13. Describe Proposed or Completed Op If the proposal is to deepen direction Attach the Bond under which the wo following completion of the involved testing has been completed. Final A determined that the site is ready for the Summary: Variance to batch	ally or recomplete horizontally rk will be performed or provide d operations. If the operation re bandonment Notices must be fi inal inspection.	, give subsurface l e the Bond No. on esults in a multiple led only after all r	ocations and measu file with BLM/BIA completion or reco equirements, includ	red and true vertical A. Required subseque ompletion in a new ir ling reclamation, hav	depths of all pertir ent reports must be iterval, a Form 316	nent markers and zones. filed within 30 days 10-4 must be filed once
submission. Chevron respectfully requests provided is a brief description wells referenced as follow:	the ability to batch dril ir of the main operational s	the HH SO 10 sequences for a	15 FED 002. T drilling and casi	he summary ng the six

Changes to APD FOR Federal Wells Batch Drill

HH SO 10 15 FED 002	6H	30-015-44367
HH SO 10 15 FED 002	5H	30-015-44371
HH SO 10 15 FED 002	4H	30-015-44353
HH SO 10 15 FED 002	3H	30-015-443

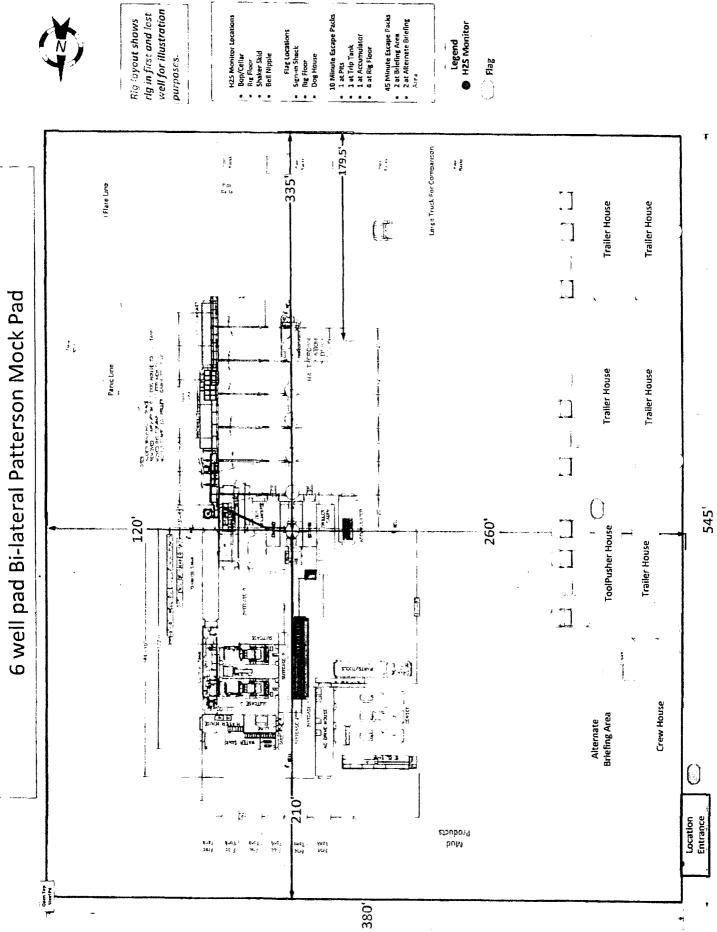
- 1. Drill 17-1/2" surface hole with fresh water to planned casing set depth with 10' rat hole.
- 2. Run casing as stated by approved APD, land out wellhead, and cement.
- 3. Dress out 13-5/8" 5M SH-2 wellhead and install/secure with temporary abandonment cap and a pressure gauge will be installed. Reference image below Part U 399984.
- 4. Skid to next well according to below "Drill Order".
